Work Order ID 71819

Item Name: Crosstube Turning Detail

DART AEROSPACE LTD	Work Order: 71819
Description: Crosstube Assembly	Part Number: D407-667-245
Inspection Dwg: D407-667-245 Rev: F	Page 1 of 1

DRAWING NO. D407-667-245	TITLE CROSSTUBE ASSY (407 HIGH AFT)	REV. F	DART AEROSPACE LTD ENGINEERING ORDER		D.E.O. NO. D407-667-245-F-1	SHEET NO. SHEET 1 OF 2	SCALE NTS
DRAWN <i>1</i>	CHECKED <i>9</i>	MFG. APPR. <i>E</i>	APPROVED <i>14</i>	DE APPR. <i>1</i>			
DATE 11.04.08	DATE 11.04.12	DATE 11.04.12	DATE 11.04.12	DATE 11.04.12

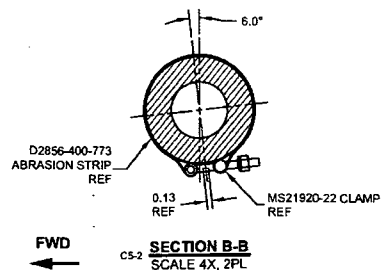
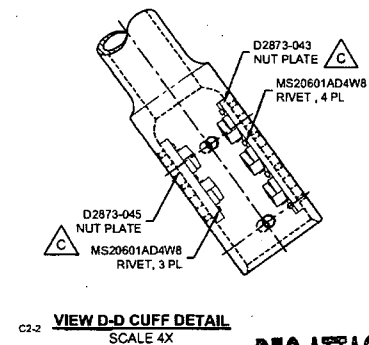
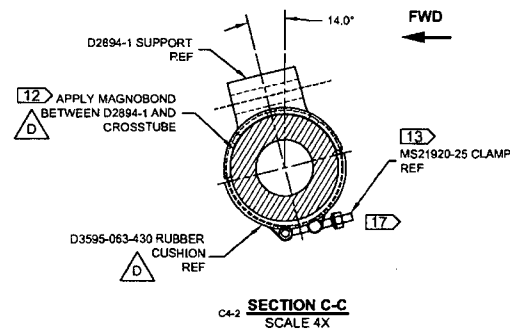
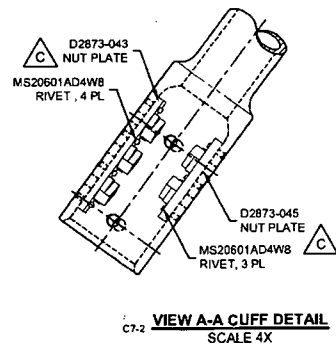
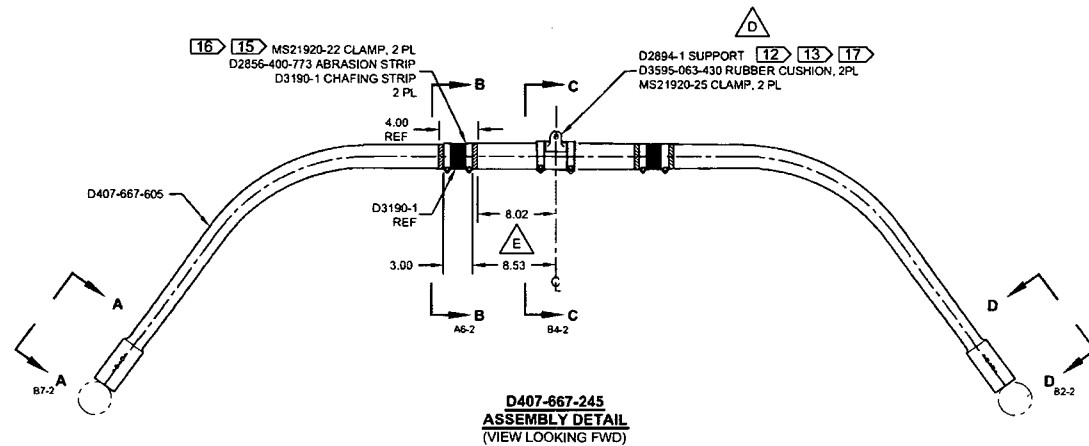
NOTES 2 AND 15, SHEET 1 ARE AMENDED AS FOLLOWS:

WAS:

- 2) FINISH: CHEMICAL CONVERSION COAT PER DART QSI 005 4.1
PRIME INSIDE AND OUTSIDE PER DART QSI 005 4.2
PAINT OUTSIDE PER DART QSI 005 4.2
- 15) INSTALL D2856-400-773 ABRASION STRIP WITH A 0.13 REF GAP ON BOTTOM SIDE OF
CROSSTUBE PER QSI 035.

IS:

- 2) FINISH: CHEMICAL CONVERSION COAT PER DART QSI 005 4.1
PRIME INSIDE AND OUTSIDE PER DART QSI 005 4.2
MASK UNDERSIDE OF CROSSTUBE AS SHOWN (HATCHED AREA) AND
PAINT OUTSIDE PER DART QSI 005 4.2
REMOVE MASKING AND APPLY CLEAR COAT
- 15) APPLY A THIN COAT OF PROSEAL 890 ON INSIDE CONCAVE SURFACE OF D3190-1
CHAFING SHIELDS AND LET CURE PER MANUFACTURER'S INSTRUCTIONS. INSTALL
PROSEAL D3190-1 CHAFING SHIELDS ONTO CROSSTUBE BY APPLYING A THIN COAT
OF PROSEAL 890 ONTO CROSSTUBE. BE SURE TO ELIMINATE ANY AIR GAPS.

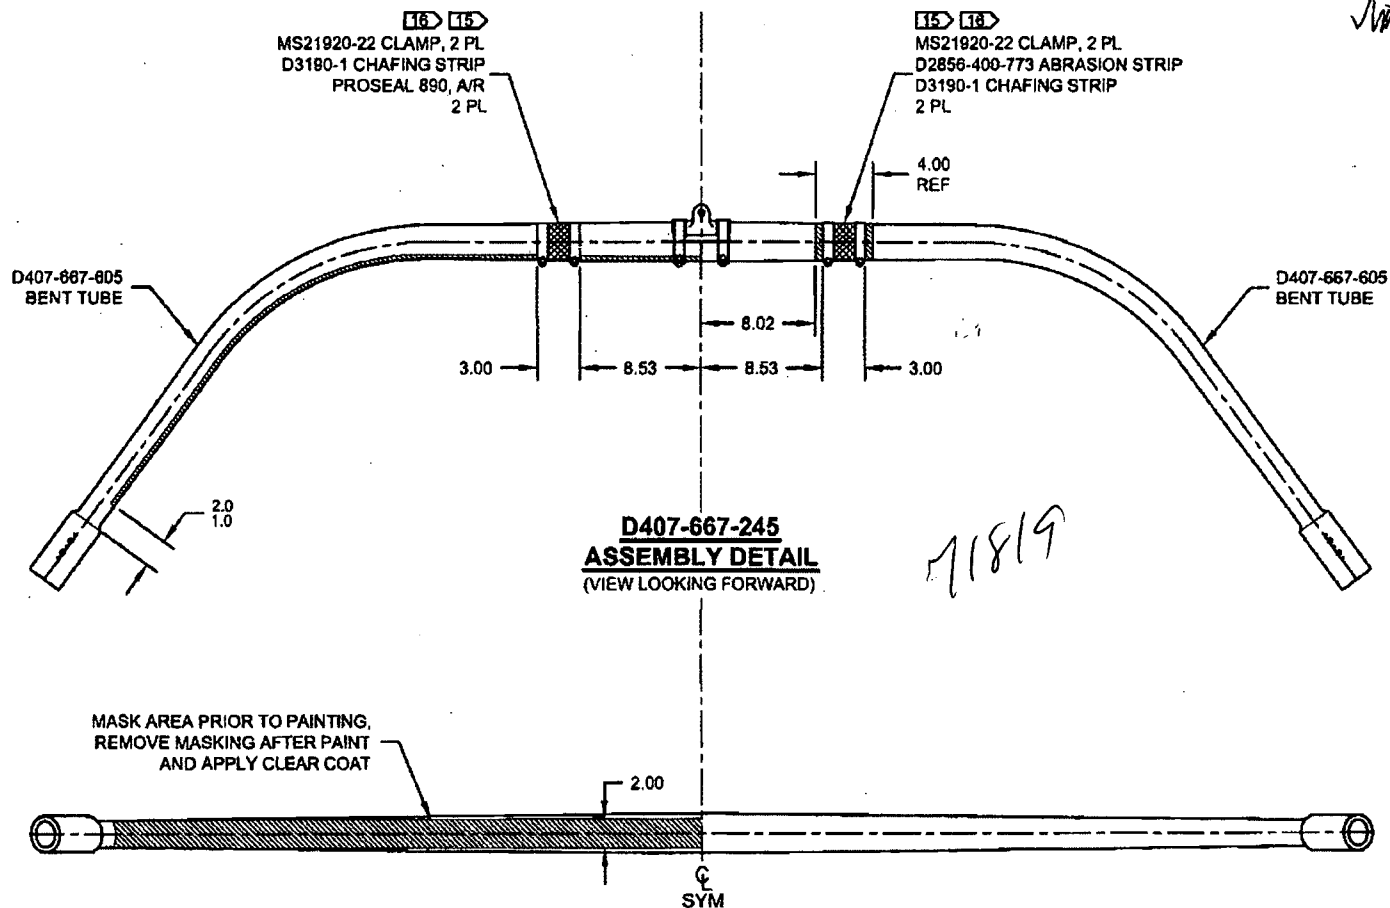
PURPOSE:

REMOVED ABRASION STRIP IN FAVOR OF A THIN LAYER OF PROSEAL 890.

IS:

WAS:
